Common Council

Agenda

SUBJECT: Recommendation of Plan Commission Regarding a Precise Implementation Plan (PIP) for proposed Notre Dame School at 100 S Huron Street (Parcel ED-1013).

ITEM X: Staff recommendation and possible action regarding a Precise Implementation Plan (PIP) for proposed Notre Dame School at 100 S Huron Street (Parcel ED-1013). Submitted by Groth Design Group. *

BUILDING ELEVATIONS

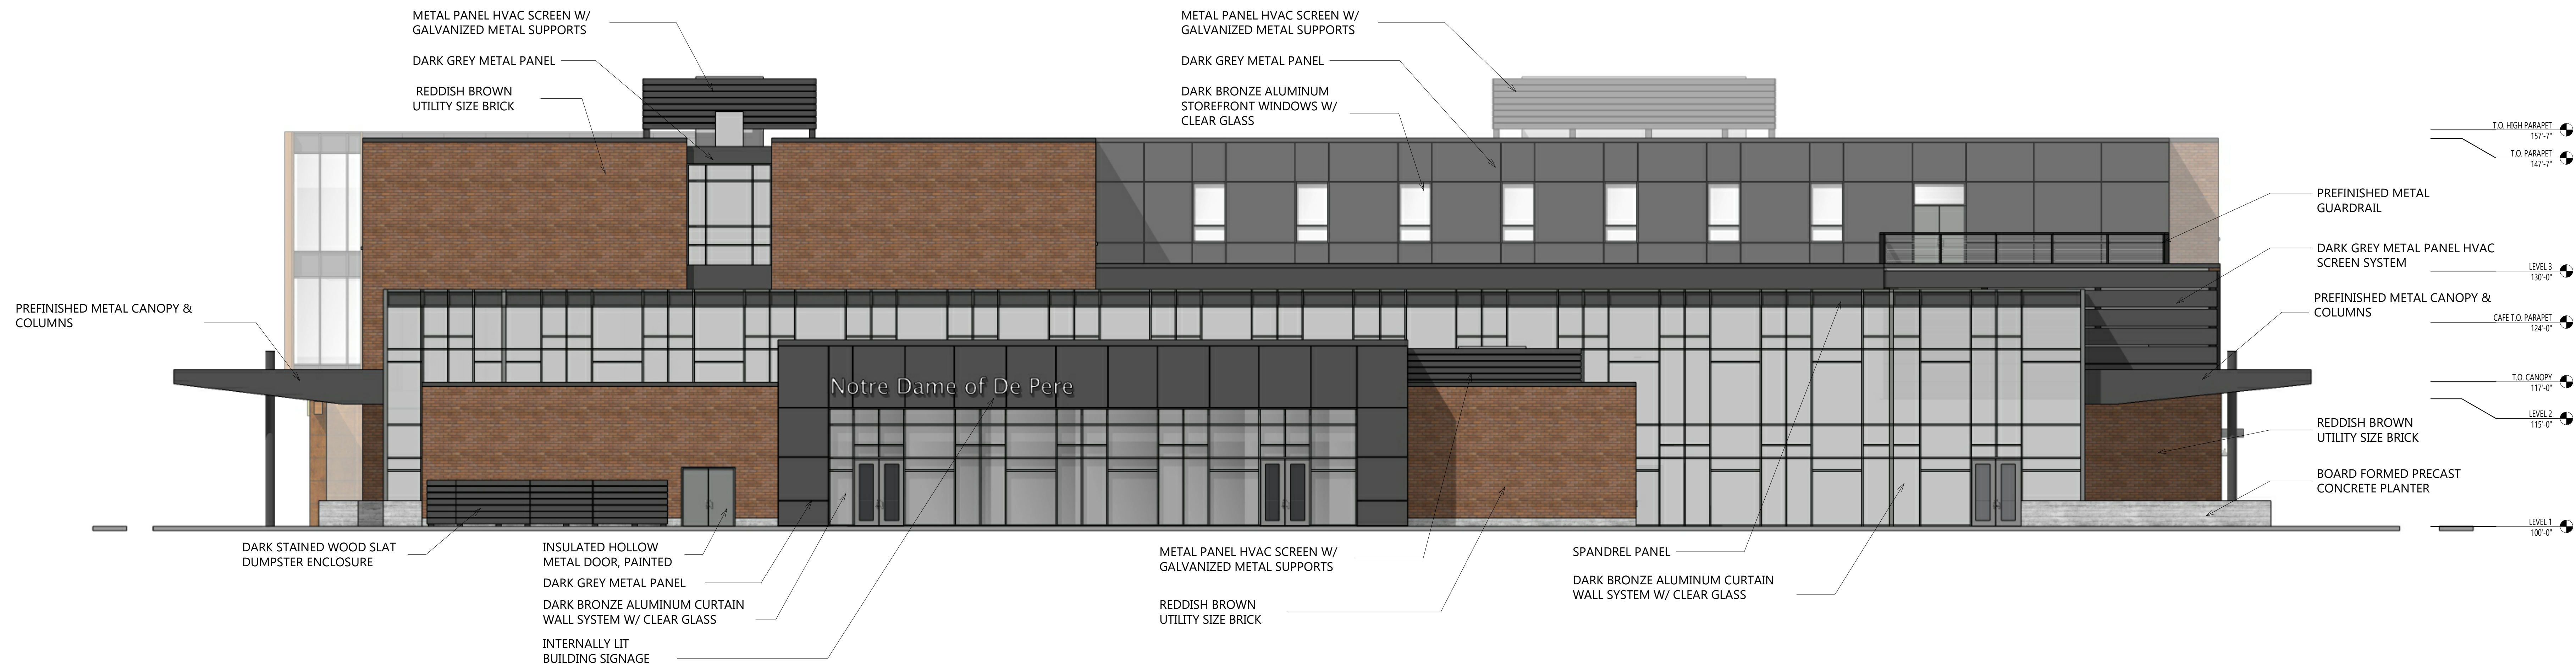
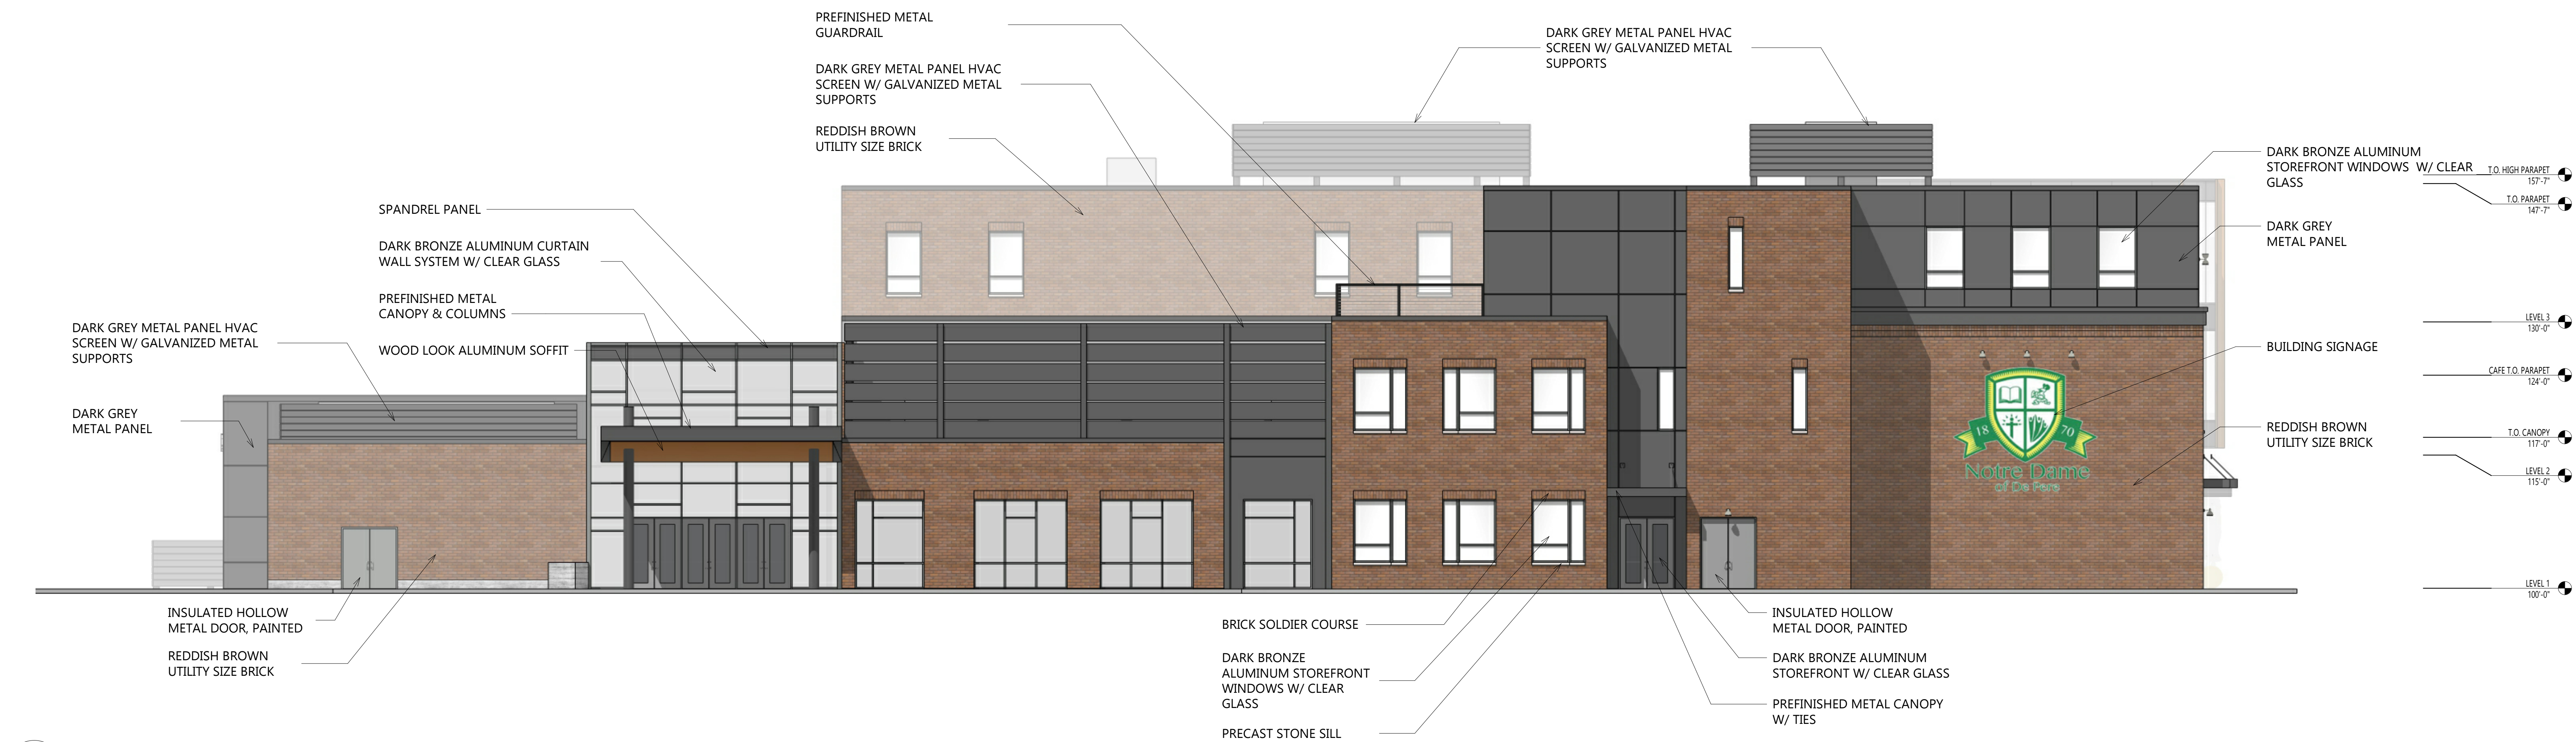
The building elevations show wall signage on the south, east and west sides. Some signs are proposed to be internally lit. Wall signage is not permitted in the R2 Zoning District. Monument signs for schools are permitted per Code Section 98-13.

This property is in a unique location because it is surrounded by B-1 Zoning Districts at the north end. Wall signs are permitted in the B-1 District, but cannot be internally lit. The applicant should revise the signage proposal in order to meet code or seek a variance from the Plan Commission. Because sign regulations are in a different section of the Municipal Code, the PDD process cannot provide a modification to sign code requirements.
